Desktop Board CC820 Specification Update

Release Date: June 2000

Order Number: 749730-004

Figure 16. Location of the Jumper Block

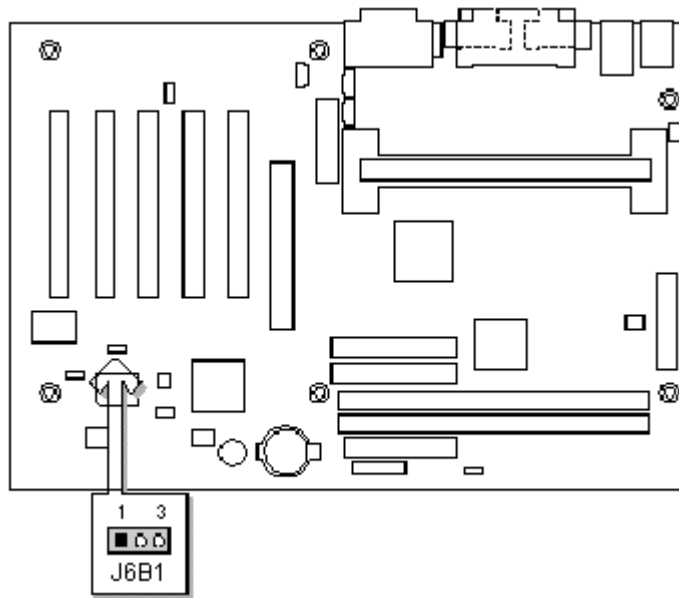
2. Add Control Jumper Block

Section 2.9.1, figure 16 and Table 47 will be added to the CC820 Technical Product Specification. All subsequent table numbers and figure numbers will be updated.

The addition of jumper block J6B1 provides additional user control over system wake events. When the jumper is in its default location (shorting pins 1-2) the system will resume from S5 when a PME or WOL event is asserted. If the jumper is placed on pins 2-3 the system will no longer resume from S5 when PME or WOL events are asserted. This jumper does not in any way impact S3 resume events. *Please note that in order for the system to resume from S5 the operating system and drivers must also be configured to enable these wake events.*
